Service bulletin # HK2000-01 Rev1 April 2001

Models: AVR35/AVR45/AVR65

Subject: No Output in Surround Modes

FIGURE 1

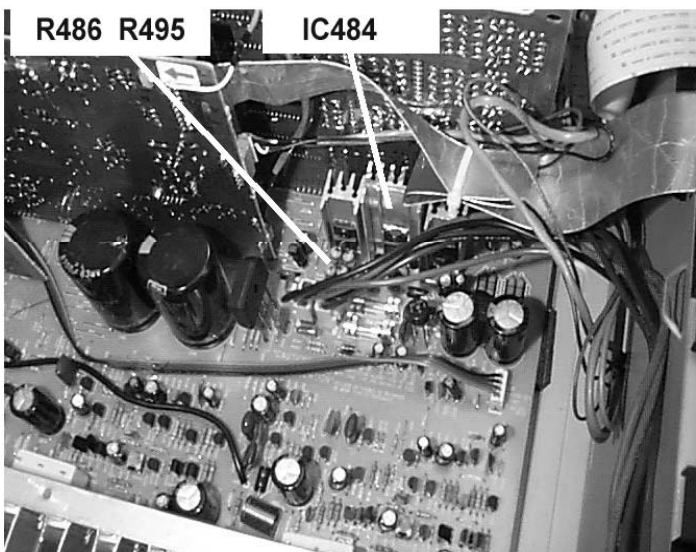
- 1) Remove the top cover, (14) Philips screws; set the unit on its side and remove the bottom cover, (8) Philips screws.
- 2) Locate R486, R495 (10 ohm 1 watt resistors) and IC484 (+5v regulator) on the MAIN PCB. See Figure 1. The parts are located near the front right corner of the MAIN PCB when viewed from the front. IC484 is attached to a rectangular aluminum heatsink.

FIGURE 2

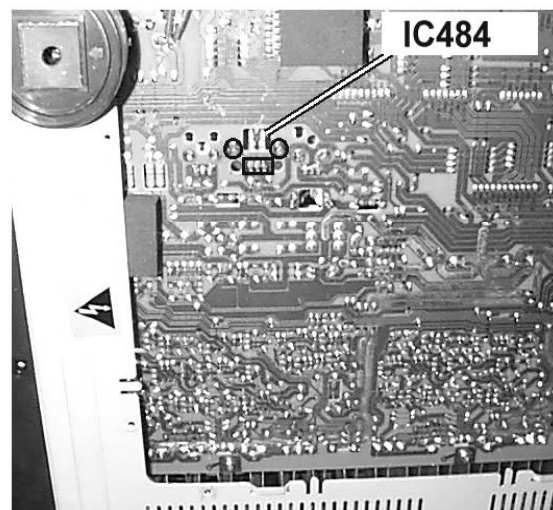
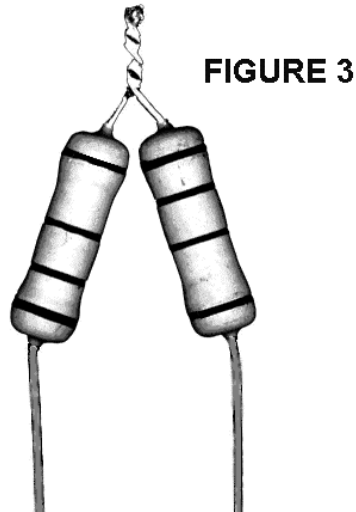
- 3) Desolder and remove R486, R495 and IC484. The IC484’s heatsink has two additional soldered connections at the bottom of the MAIN PCB. See Figure 2.

- 4) Replace R486 and R495 with (2) 15 ohm 3 watt resistors, (h/k part# J1771150771X), soldered in series to measure 30 ohms each. See Figure 3. Replace IC484 with +5v regulator, J1217780002X).

- 5) Replace heatsink with new larger part, (h/k part# J5241003040XX)
- 6) Use silicon grease when attaching the new regulator to the heatsink, and tighten it sufficiently with its single mounting screw before re-soldering in place.
